Camden County Planning Board Agenda for May 28th, 2019

**CAMDEN COUNTY PLANNING BOARD
COUNTY ENGINEER'S REVIEW
OF SUBDIVISIONS AND
SITE DEVELOPMENT PLANS**

**COUNTY PLAN:
SP-34-8-17/M-34-4-17**

**COUNTY PLAN:
MJ-36-2-19**

OVERALL SITE PLAN

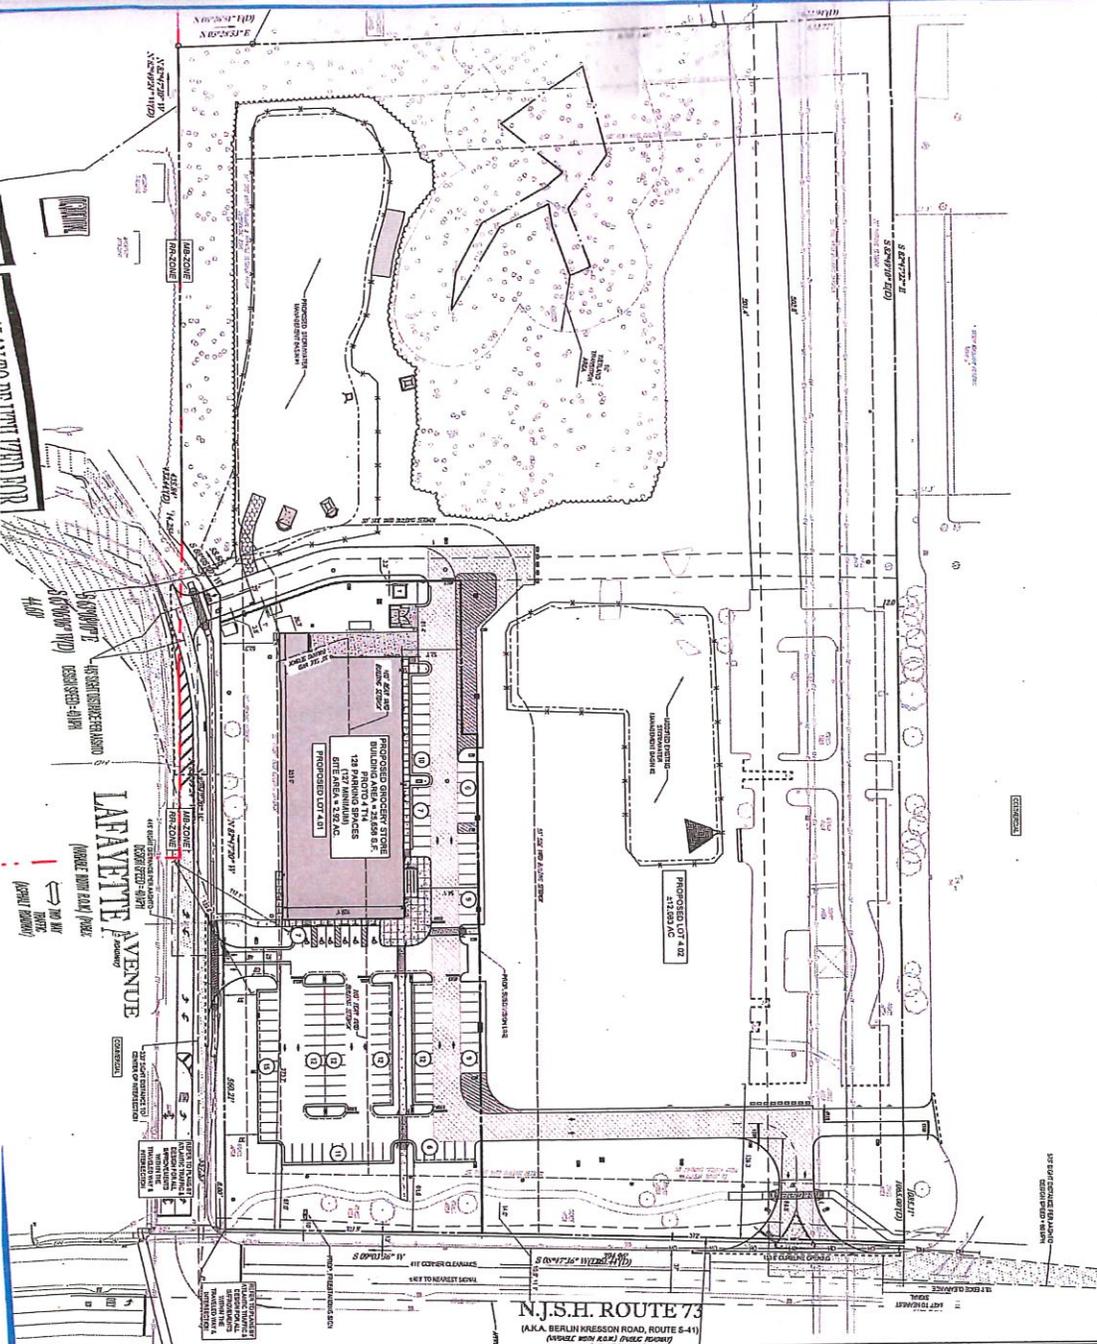
1. The plans should include a note indicating "All sidewalk and curb within the County right-of-way along the property frontage that is deteriorated or presents a tripping hazard shall be replaced under the direction of the County Engineer or his/her representative."

2. Sight Triangles are shown on the proposed improvements plans. Landscaping and proposed improvements appear to be proposed outside of the sight triangles. A note should be added to the plans indicating that all improvements located within the site triangle shall be maintained to height no higher than 30" or lower than 84" above the driveway grades.

3. Site Plans Must Conform with the Following Standards:
 - 3.3.1.1 Marginal Access Roads, Service Road, and Common Driveways
Truck access should be limited to NJSH. Rt. 73. Signage restricting truck access to Lafayette Avenue should be depicted on the plan together with appropriate details.

The gore should be modified at the driveway intersection proposed adjacent to the westerly property line of lot 4.01 to facilitate ingress and egress.

10. Lafayette Avenue is in very poor condition. The applicant proposes to repave the roadway along the frontage of the site and upgrade all inlets to meet the current NJDEP requirements. Camden County recommends that the applicant provide a fair share contribution for future roadway improvements to Lafayette Avenue and intersection upgrades to Lafayette Avenue and Haddonfield-Berlin Road.

11. The applicant should provide an assessment of the sight distance for the Shopping Center driveways on Lafayette Avenue as there is heavy vegetation and a horizontal curve just west of the site.

12. The applicant should provide a Road Improvements Plan for Lafayette Avenue, which include the following:
 - a) The speed limit on Lafayette Avenue is 35 mph. As there is additional traffic projected to/from the site and traffic signal, the applicant should discuss potential speeding and traffic calming measures on Lafayette Avenue. The applicant should work with the County, in conjunction with the Township, to determine appropriate traffic calming measures.

STAFF REPORT MEETING OF:	RE:	Pilgrim Woods
	Plan:	MJ-36-2-19
	Municipality:	Winslow
	Applicant:	Glouco Approvals Group, LLC (c/o Ralph Ford)
	Abuts County Route:	Blue Anchor Rd. (CR 720)

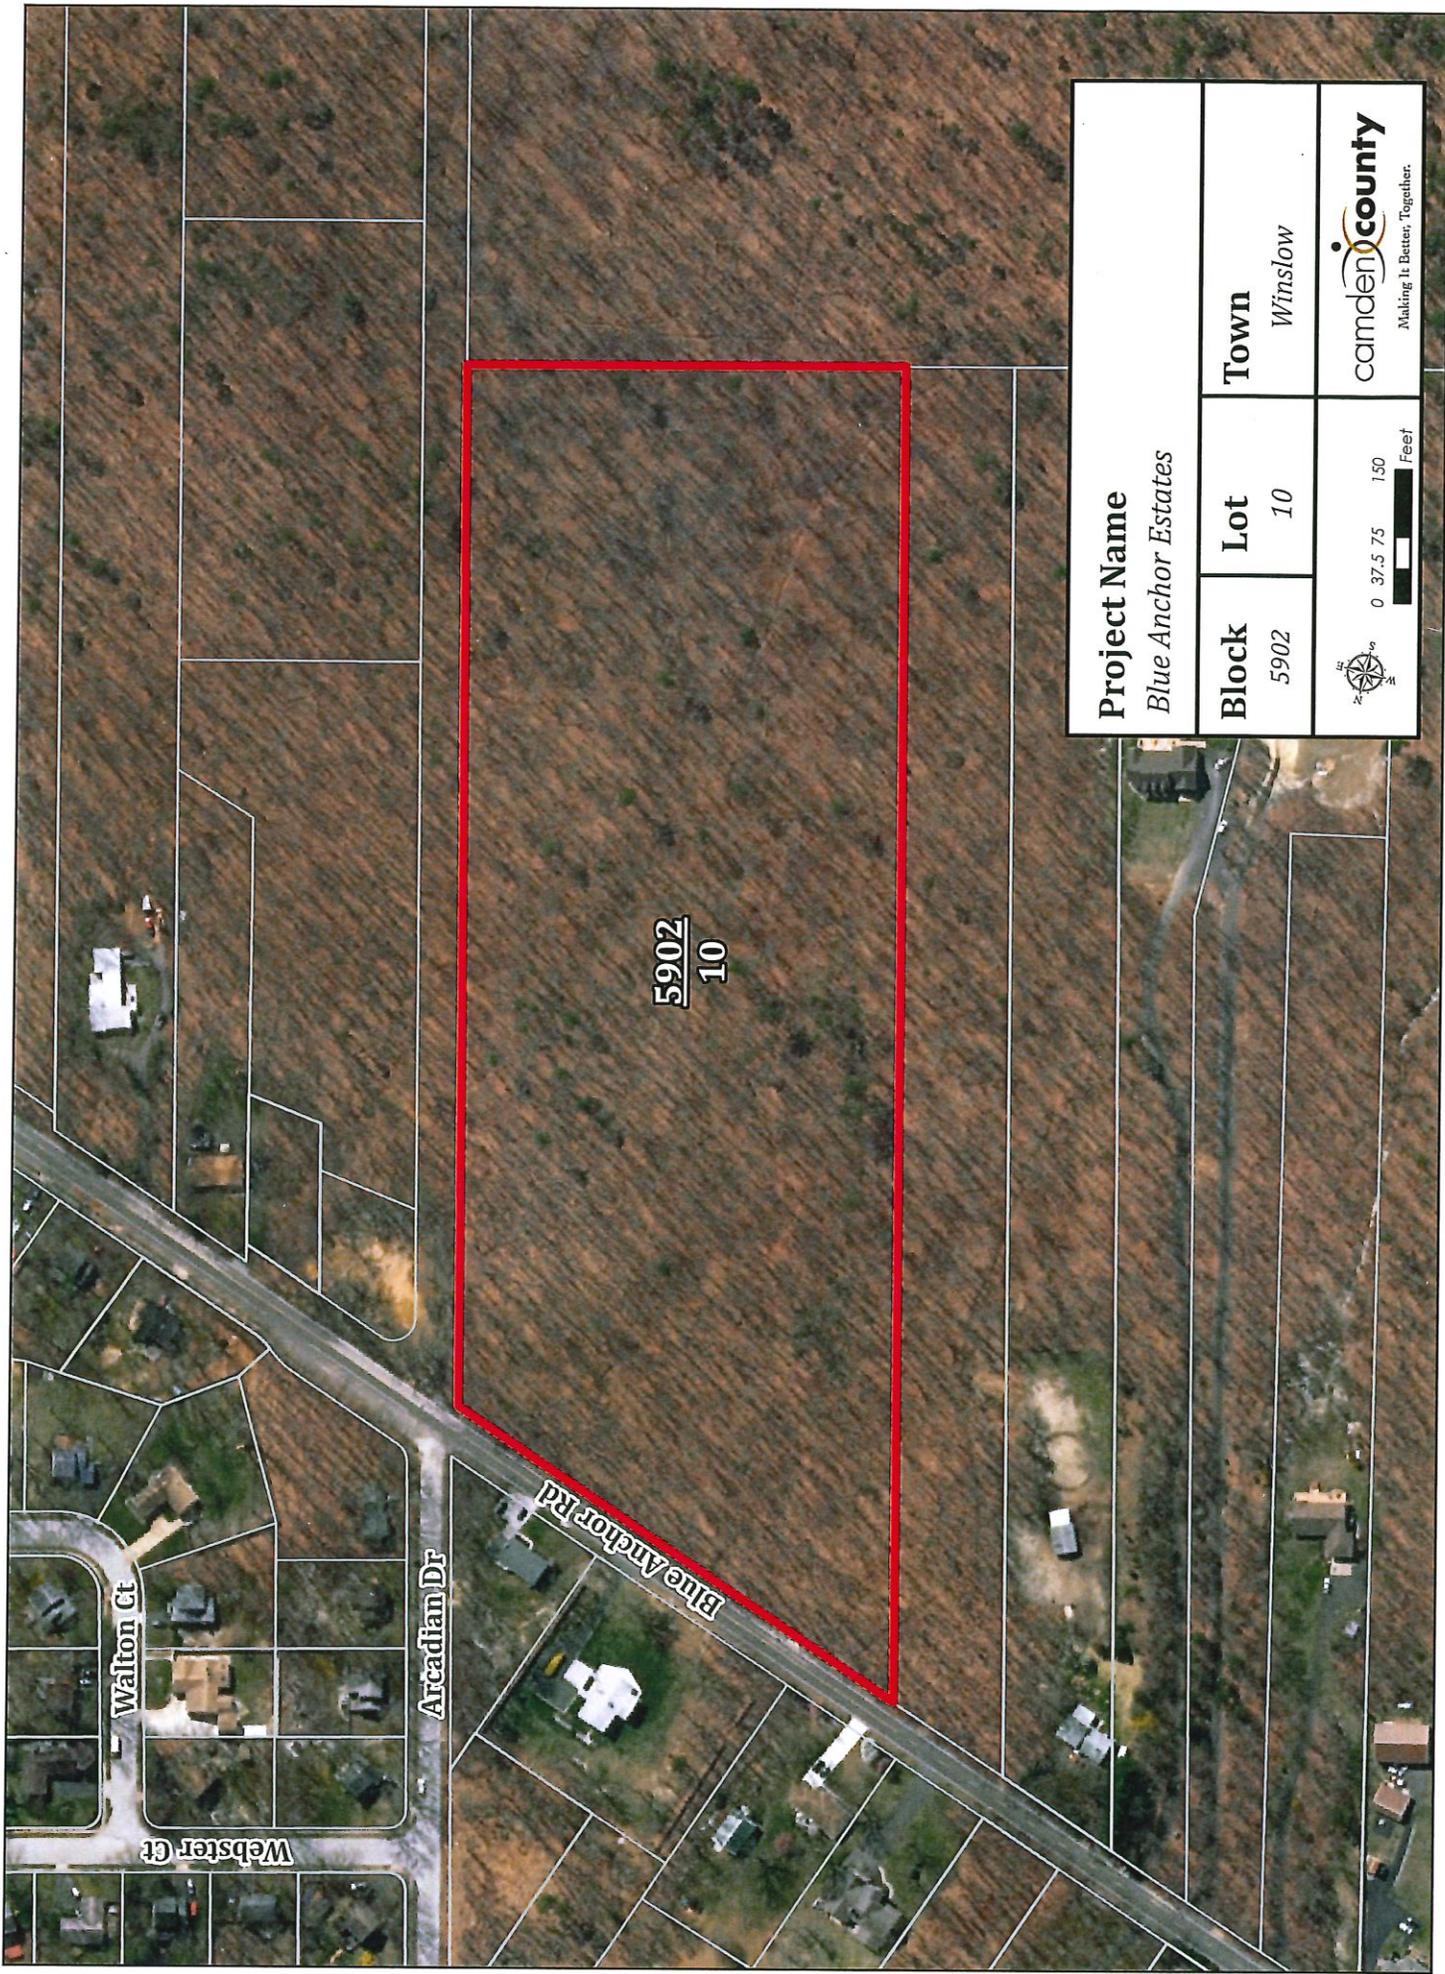
1. The Camden County Master Plan indicates that New Brooklyn- Blue Anchor Rd (CR 720) has a proposed right-of-way of 60 feet, with an existing right-of-way of 49.50 feet. The applicant is required to provide additional right-of-way through a roadway easement to widen New Brooklyn- Blue Anchor Rd (CR 720) 10.25ft from the centerline along the applicant's frontage.
The following is noted:

- a. The site plan should be revised to indicate the roadway easement dedicated to Camden County.
- b. The metes and bounds description of the roadway easement prepared by a licensed surveyor in the State of New Jersey should be submitted for prior review and approval.
- c. A copy of receipt of County filing of the road widening easement must be provided to the County Planning Department prior to issuance of final approval.

4. The following comments are provided regarding the calculations, SWM Report and Plans:
- a. Drainage Area (DA) 3 in the existing conditions map shows two Time-of-Concentration (Tc) Paths which would indicate two separate sub-areas and points of analysis (POA). Please revise accordingly.

- b. Existing conditions routing results for DA-3 and DA-4 do not match summary Table 1 in Section 3.01 of the report. Please revise accordingly.
 - c. Revise weir elevation for Post Berm 3B in routing analysis to match plan elevation.

- d. Revise weir elevation grade on Post DA Map for Berm 4B.
 - e. Show Tc path and POA location on Post DA Map for DA 5.
 - f. With regards to the post construction routing analysis for the proposed infiltration basin, the HDPE pipe slopes in the HydroCAD computations do not match the slopes labeled in the plans. Please revise accordingly.

- g. With regards to the sediment forebay outlet structure routing in HydroCAD, the 24" HDPE pipe culvert should be selected as the "primary" outfall. The 6" low flow orifice and the 42"x54" grate(riser) should be modeled as "Device #1" for both as they are controlling flows to the primary outfall. The emergency spillway (riprap weir) should be modeled as a "secondary" outfall. Please revise accordingly.

- h. Same comment as above with applicable invert data applies to basin outlet structure modeling. Please revise accordingly.
 - i. Correct outflow data in Table 1 of Section 3.01 for basin outflow DA-6.

- j. For the inlet and storm sewer conduit design, was the total spread evaluated for the sag locations and along the curb? Applicants engineer is requested to provide testimony regarding this item.

- k. Add a note to the basin notes restricting construction and placement of infiltrating sand bed and final conversion of the permanent BMP until all contributing drainage boundaries have been vegetatively stabilized.

- l. Temporary ponding water surface in basin for the 10 Year Storm (and higher storms) exceeds 3' in maximum depth. Please coordinate with County for the assistance on meeting this requirement. (basin embankment for grading change from 4:1 to 3:1 slope.)

- m. Please provide any details on the downstream conveyance at POA DA-6 where the site discharges to Arcadian Drive. Will discharge flows have positive conveyance or will the discharge flows pond in this vicinity?

1. The Roadway Improvement Plan, Sheet 11 of 13, dimensions a 75-foot long and 9-foot wide acceleration and deceleration lane. Applicant has designed the requested acceleration and deceleration lanes per County Standard Detail No. 22, Bypass Area.
2. Applicant shall revise design to provide the Minimum 12-foot lane width per County Standard Acceleration and Deceleration Lanes Detail No. 13; or receive concurrence from the County the bypass area design is adequate to support proposed traffic operations at the site access.
3. Applicant shall dimension proposed lane widths and shoulder widths.
4. Applicant shall detail proposed signing and striping at the site access on Sheet 4 of 13, Site Plan Layout per the applicable County Standard Details.
5. Applicant shall include Standard Pavement Marking Legend, County Standard Detail No. 10, as part of the revised plans.
